**Re: Dominion Energy Ohio Letter of Notification for PIR 782
Case No. 18-560-GA-BNR**

**Dominion Energy Ohio Construction Notice for PIR 782 Pipeline Replacement Project
Case No. 18-560-GA-BNR**

Responses to Staff's First Data Request

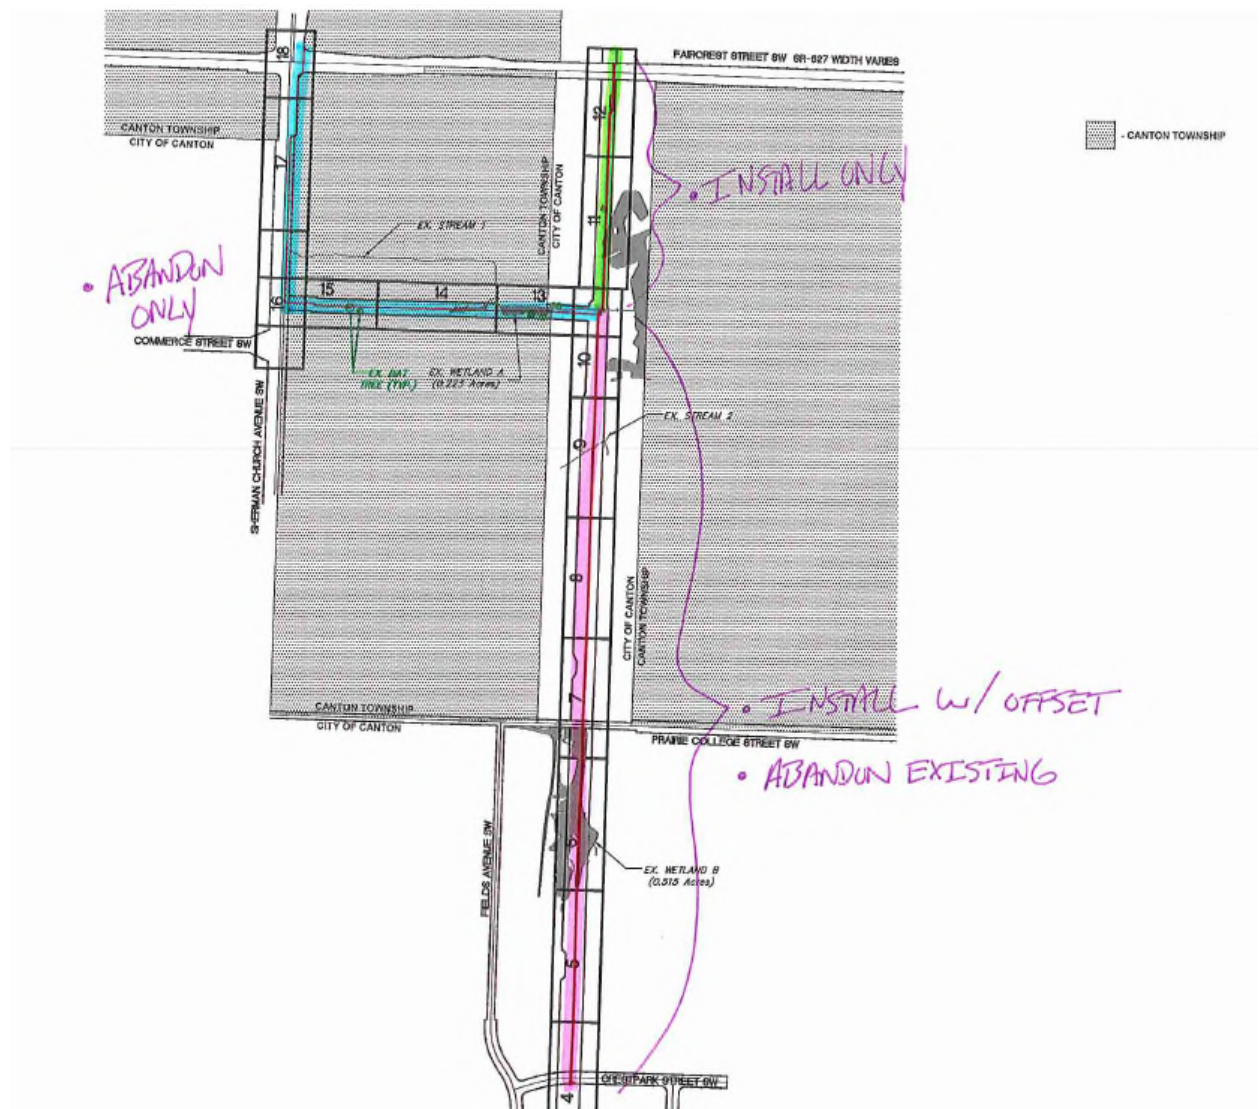
5. What is the percent capacity the current pipe operates at on peak day?

RESPONSE:
